PG&E Comments on Proposed Changes to Nonresidential Lighting Retrofit Requirements in 2016 Title 24 Standards

2016 CALIFORNIA BUILDING ENERGY EFFICIENCY STANDARDS

March 19, 2015

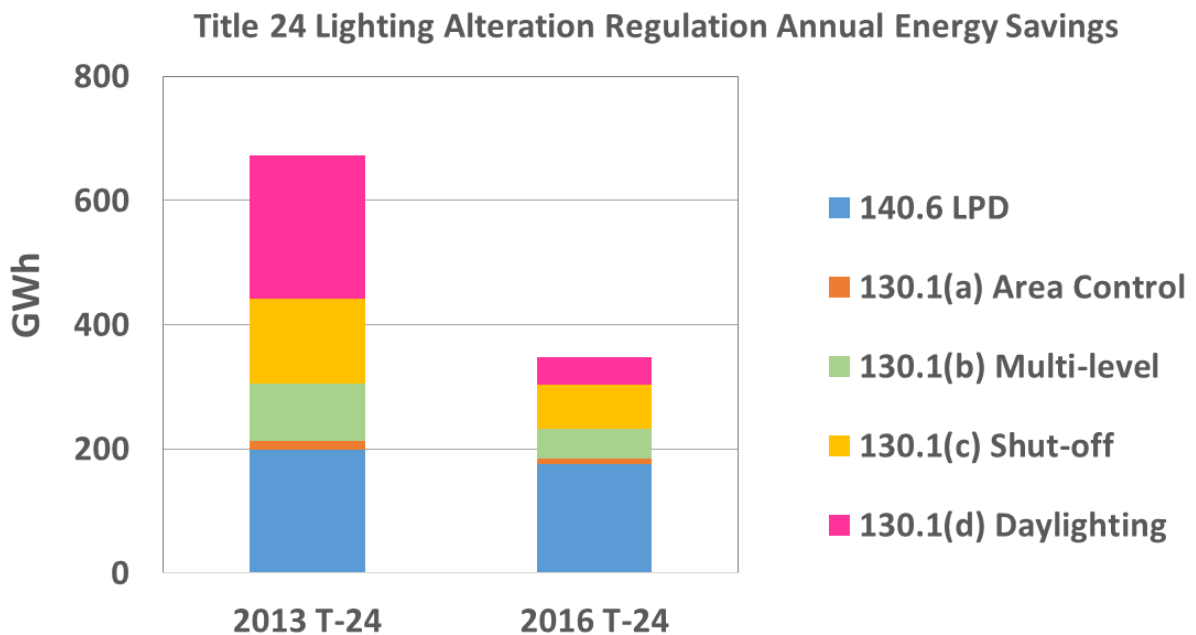
The CEC staff's proposed effective removal of the daylighting requirements could result in a significant loss in energy savings between the 2013 and 2016 Title 24 standards. See the graph below, which indicates estimated annual energy savings for each year's retrofit construction activity.
